CITY OF FORT LAUDERDALE

# DEVELOPMENT REVIEW COMMITTEE

## CASE COMMENT REPORT

<b>CASE:</b>	UDP-S24014
<b>MEETING DATE:</b>	March 26, 2024
<b>REQUEST:</b>	Site Plan Level II Review: Community Park with 9,320 Square-Feet of Community Center, Multipurpose Fields, Playground, Dog Park, and 16 Pickleball Courts
<b>APPLICANT:</b>	City of Fort Lauderdale
<b>AGENT:</b>	Marc Isaac, Parks and Recreation Department
<b>PROJECT NAME:</b>	Lockhart Community Park
<b>PROPERTY ADDRESS:</b>	5101 NW 12th Avenue
<b>ZONING DISTRICT:</b>	General Aviation Airport (GAA)
<b>LAND USE:</b>	Transportation
<b>COMMISSION DISTRICT:</b>	1 – John Herbst
<b>NEIGHBORHOOD ASSOCIATION:</b>	N/A
<b>CASE PLANNER:</b>	Jim Hetzel

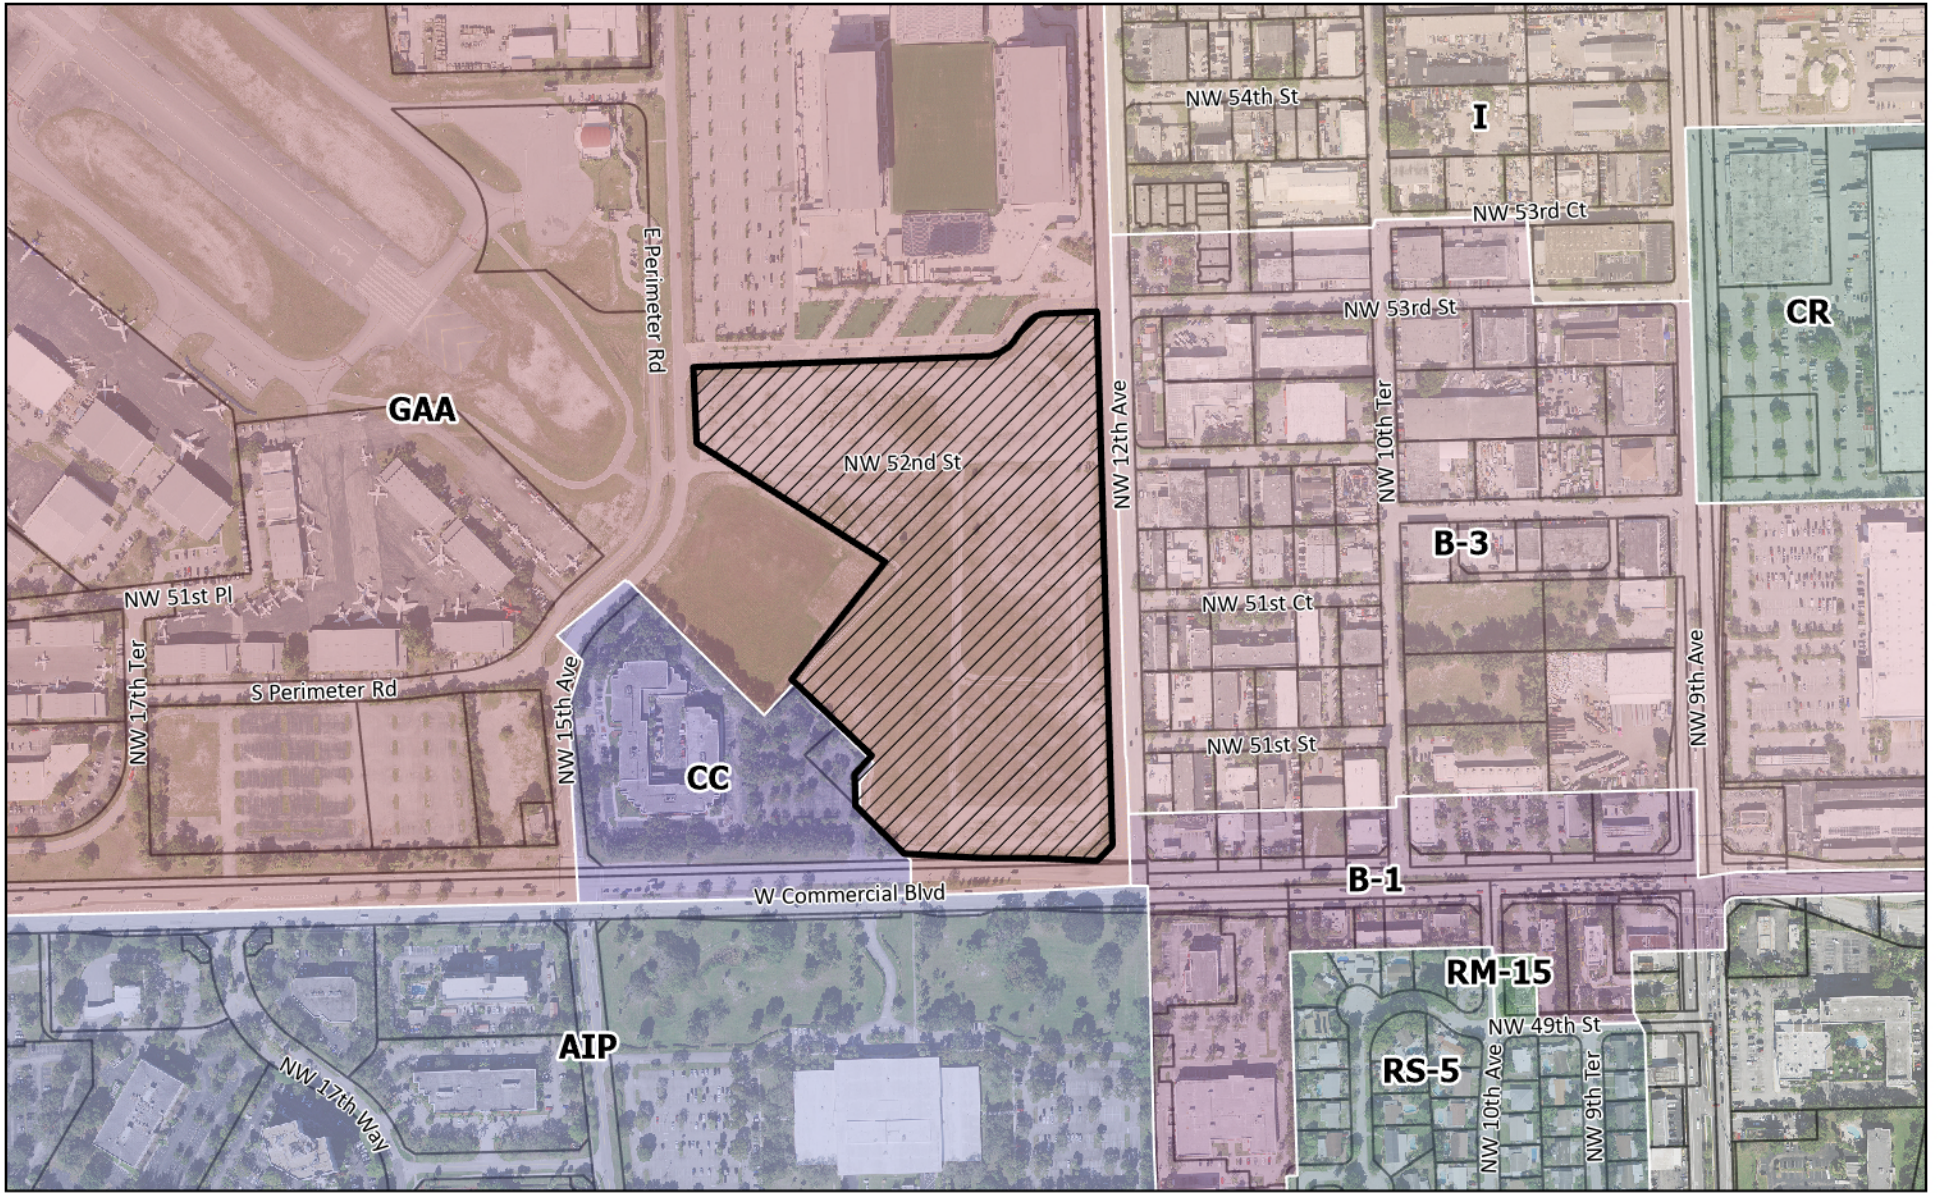
15. Pursuant to ULDR, Section 47-20, Parking and loading requirements:
  - a. Sheet G003, there are two parking data tables in the site data. Remove the duplication and provide one table.
  - b. Parking for open space shall be calculated for only the open area minus buildings, courts, fields, dog park, water feature area, maintenance building, etc. Recalculate based on the remaining area.
  - c. Plan indicates there are 126 paved parking spaces; however, this number may change based on revised calculations.

- d. All parking shall be provided on paved surface unless the use of the property is limited to three days or less. As proposed, there is overflow grass parking but no information on the number of spaces and operations of the park.

- e. The site is currently used for parking related to Chase Stadium. Indicate where the existing parking will be located once site is developed.
16. Pursuant to Section 47-20.14, provide a site lighting plan with photometrics values extending and shown to the property lines. Provide details for site poles.
